BCA Design Assessment Report

28-32 Somerset Street  
Kingswood NSW 2747

Project: 28 -32 Somerset Street, Kingswood NSW 2747  
Document Type: BCA Design Assessment Report  
Our Reference: P220\_430-3 (BCA) JR

**Figure 2.1 – Basement 2 level**

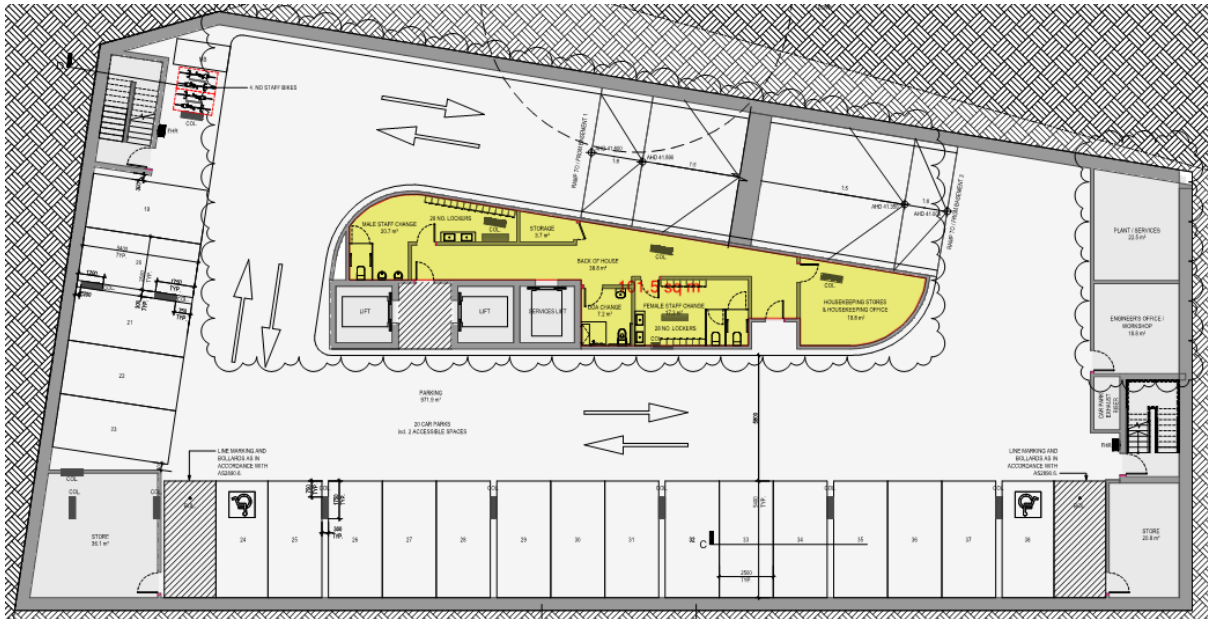
- (i) The bar area and rooftop bar and dining area have been assessed achieving a class 6 classification;
- (ii) The required stairway serving the basement carpark levels have been assessed as fire isolated stairways;
- (iii) The area highlighted in the figure below has been assessed as being ancillary to the class 3 part, with the corridor serving each room being a public corridor with requirements of bounding construction required under C3.11 applicable to these parts;

- (iv) Each unit has been treated as a separate sole-occupancy unit;
- (v) Travel to alternative exits from the point of choice have been treated as being  $\geq 45^\circ$  apart within the basement;
- (vi) The storage rooms within the basement 2 level accounts for less than 10% of the total floor area of the storey and hence a class 7b classification for the storey has not been considered.

**Figure C1.1** – Northern fire isolated stairway serving basement carpark levels

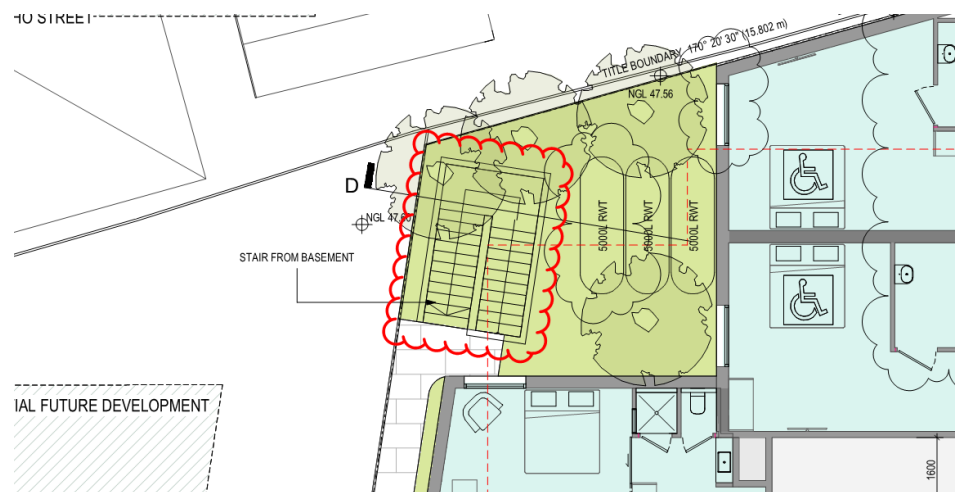
**C1.1** The northern fire isolated stairway serving the basement carpark levels is noted as being unenclosed (i.e. open to the elements).

Figure C2.14 – Level 1 Public Corridor

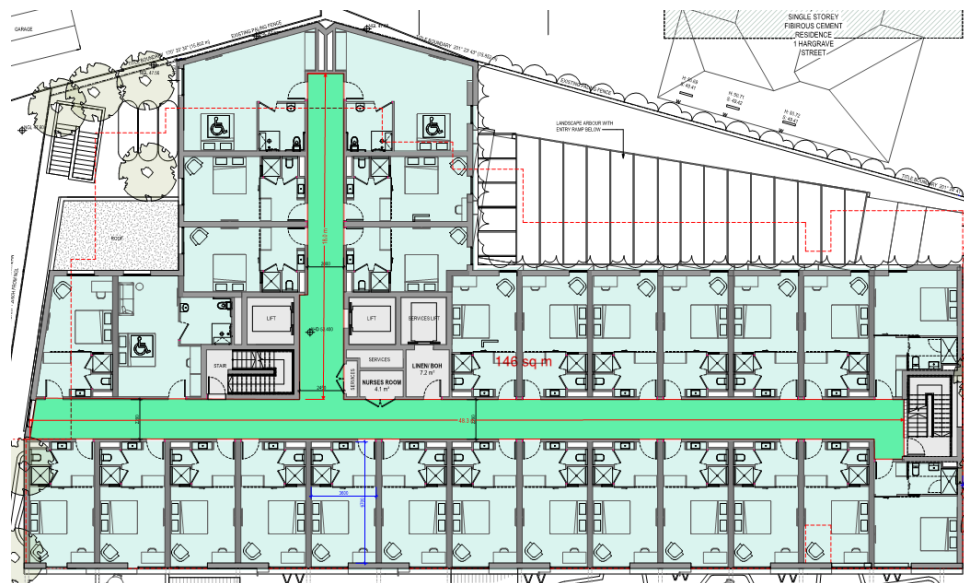
The public corridors on levels 1-5 are noted as exceeding 40m in length without provision of smoke proof walls (being up to ~67m at worst case, occurring on level 1), as highlighted in the figure below.

To address the compliance departure identified above, the following options are offered for resolution –

- (i) Introduce a smoke proof wall complying with Clause 2 of Spec. C2.5 along the public corridors at a distance not exceeding 40m, from one end of the corridor; or
- (ii) Justify the proposed configuration of the public corridors via a performancebased solution, demonstrating compliance with the performance requirement/s of the BCA.

Notwithstanding the above, public corridors in the class 3 parts exceeding 40m in length to be divided into intervals of not more than 40m by smoke proof walls complying with Clause 2 of BCA Specification C2.5.

Figure C3.2a – Ground Floor plan

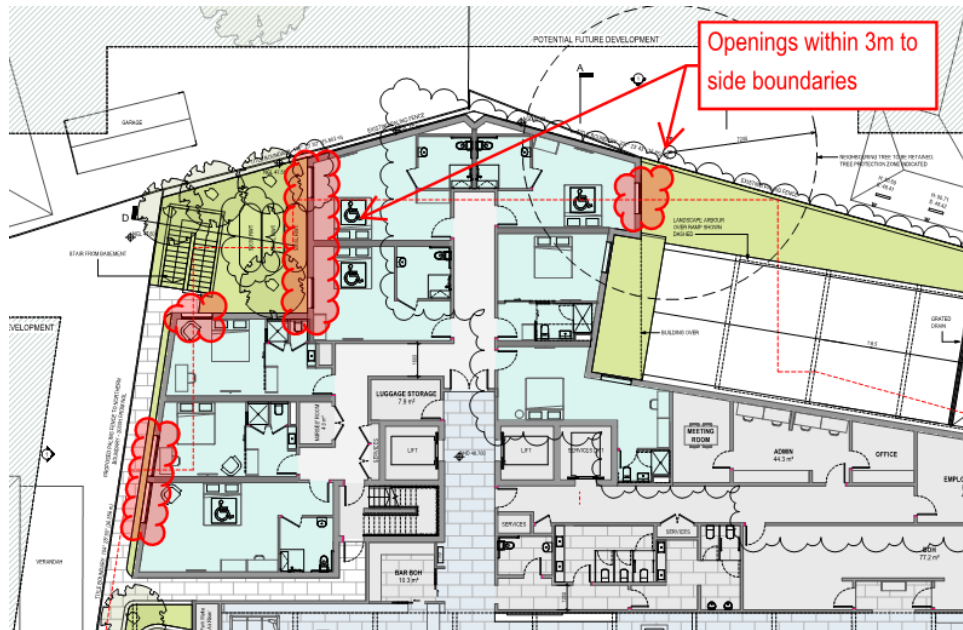
Openings in external walls, as highlighted in figures below are noted as being less than 3m from the side boundaries of the allotment and hence must be protected in accordance with C3.4 and if wall-wetting sprinklers are used, they are located externally.

Alternatively, the non-protection of openings may be justified via a performance-based solution / fire engineering report, demonstrating compliance with the relevant performance requirements of the BCA for prevention of fire spread.

Figure D1.4a – Level 1 Extended Exit Travel Distance

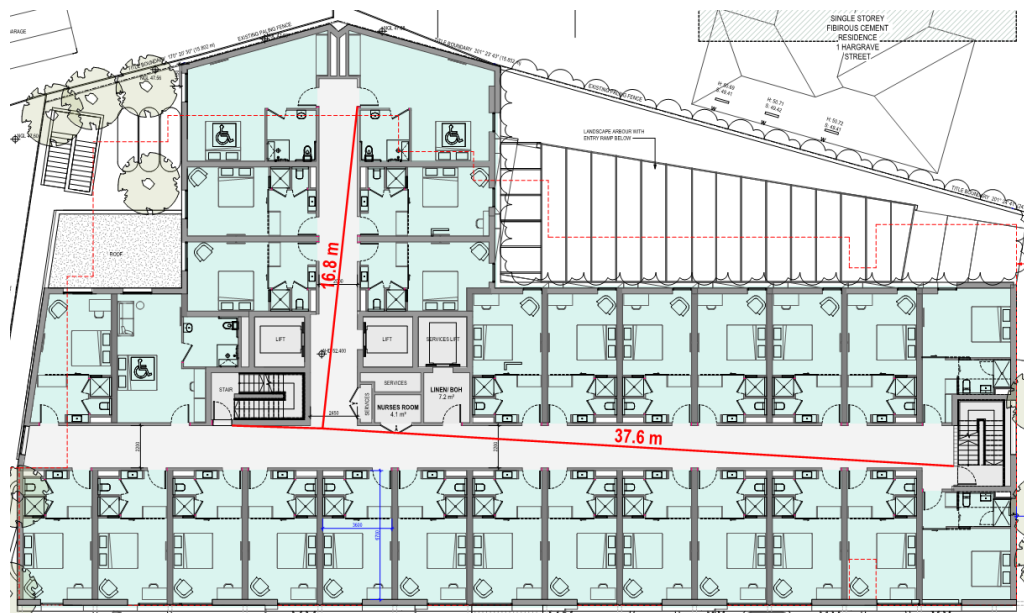
D1.4 Extended exit travel distances occur within the residential levels with the distance from the entrance doorway of an SOU to a point of choice to alternative exits within the residential levels 1-3 exceeding 6m, being up to 17m.

The extended exit travel distance/s identified above are indicated in the figures below.

To address the extended exit travel distances identified, the following options are offered for resolution –

- (i) Re-configure the level 1-3 layouts so that the distance from the entrance doorway of SOUs to a point of choice does not exceed 6m;
- (ii) Justify the extended exit travel distances identified via a performance-based solution, demonstrating compliance with the relevant performance requirement/s of the BCA.

Figure D1.6 – Rooftop Storey Types of Use

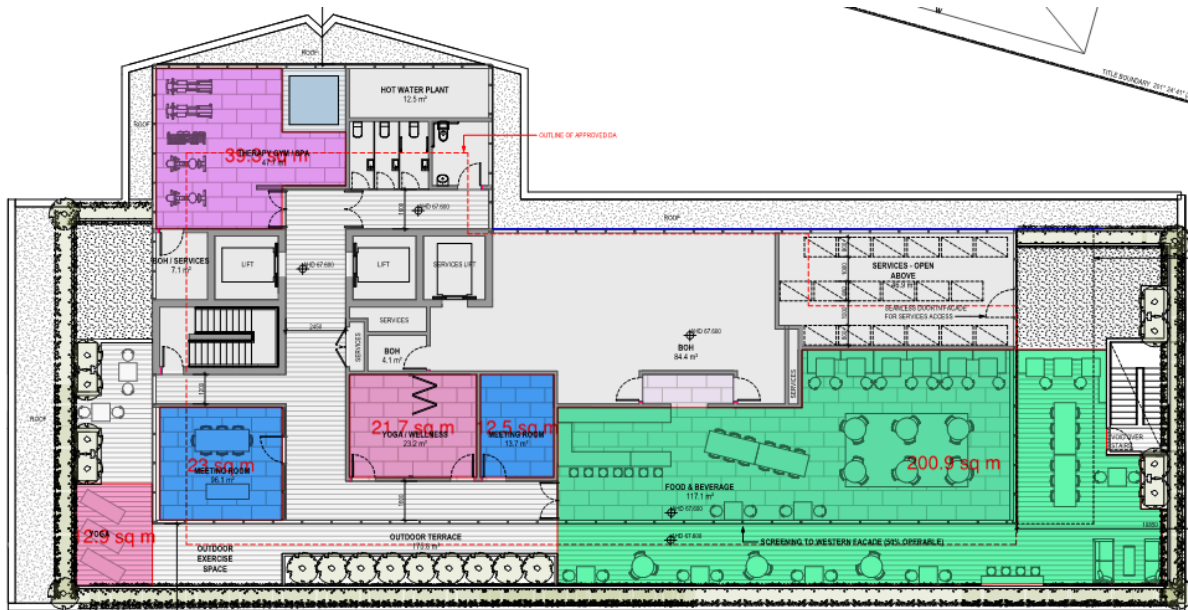
D1.6 The proposed rooftop storey is noted as having a combination of uses, including a bar and dining area, meeting spaces and gymnasium/yoga (with the use of the BOH area unknown and hence excluded) which when determining the number of persons accommodated in accordance with D1.13 of the BCA, will accommodate up to 229.

The determination of occupant loads, appropriate to each use is summarized in the table below, with corridors, hallways lobbies and the like excluded from the determination of area.

TYPE OF USE	AREA PER PERSON	AREA	NUMBER OF PERSONS ACCOMMODATED
Bar / Dining	1m <sup>2</sup> per person	200m <sup>2</sup>	200
Gymnasium	3m <sup>2</sup> per person	75m <sup>2</sup>	25
Meeting	10m <sup>2</sup> per person	36m <sup>2</sup>	4

Based on an occupant load of 229 to the rooftop storey, the aggregate unobstructed width of the fire isolated stairways must be not less than 2.5m and extended throughout the exits to the point of discharge at the ground floor. However, the proposed fire isolated stairways serving the rooftop storey are provided with an unobstructed width of ~1.9m.

To address the reduced aggregate unobstructed width to the subject fire isolated stairways, the following options are offered for resolution –

- (i) Re-configure the required fire isolated stairways so that the aggregate unobstructed width for both exits is not less than 2.5m or modified appropriate to the number of persons accommodated when determined in accordance with D1.6 & D1.13 of the BCA;
- (ii) Justify the reduced aggregate unobstructed width to the subject fire isolated stairways via a performance-based solution / fire engineering report, demonstrating compliance with the relevant performance requirement/s of the BCA.

Figure D1.7 – Discharge configuration

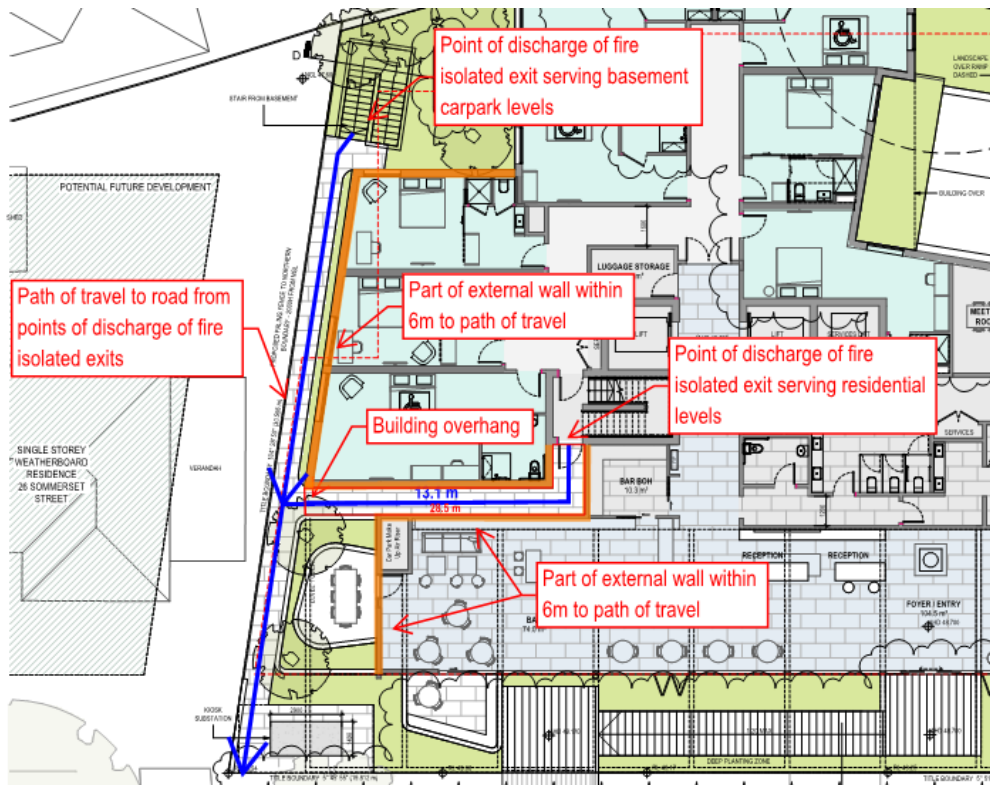
It is noted that the northern fire isolated stairway discharges to a covered area that is not open for at least 1/3 of its perimeter (being ~15% or 1/6.7) and provides an unimpeded path of travel from the point of discharge to the road or open space of exceeding 6m (being up to ~13m).

To address the reduced clearances and distances within the covered area, the following options are offered for resolution –

- (i) Extend the fire isolated exit with a passageway that terminates in line with the external wall of the bar area that is perpendicular to the path of travel such that the discharge occurs at a covered area that complies with the requirements of D1.7 of the BCA; or
- (ii) Justify the proposed configuration of the discharge area via a performance-based solution, demonstrating compliance with the relevant performance requirement/s of the BCA.

Figure D2.4 – Southern fire isolated stairway

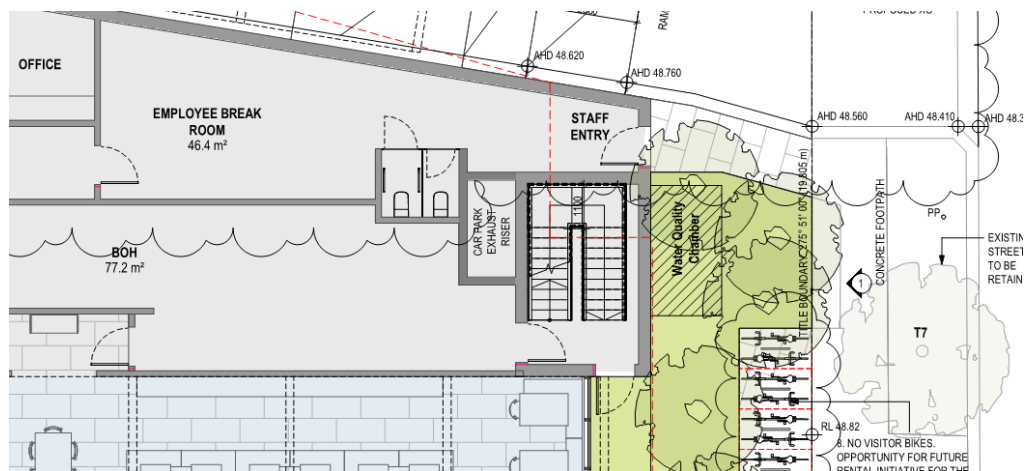
D2.4 The rising and descending stair flights within the southern fire isolated stairway are directly connected without any separating construction.

There must be no connection between a flight rising from a storey below the lowest level of access to a road or open space, and the flight descending from a storey above that level.
